SB Number:	SB PFP-010	Creation Date: 07/02/2005
Subject:	Attachment of 'HEATER, DEHUMIDIFIER' to PF-640/645/647 for FS-C8026N	
Model:	PF-640, PF-645, PF-647

PF-640/645/647: Paper feeder for FS-C8026N

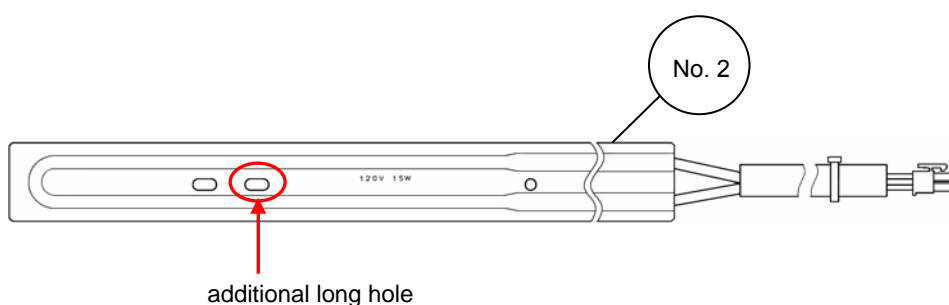
Please be informed that the following change has been implemented to the optional '**HEATER, DEHUMIDIFIER**' in order to be able to attach it to the **PF-640/645/647** for FS-C8026N.

A long hole has been created in the '**HEATER, DEHUMIDIFIER (240)**'.

When the optional '**HEATER, DEHUMIDIFIER (240)**' is attached to the **PF-640/645/647** installed to a FS-C8026N, please mind to fix it with a screw through the newly added long hole.
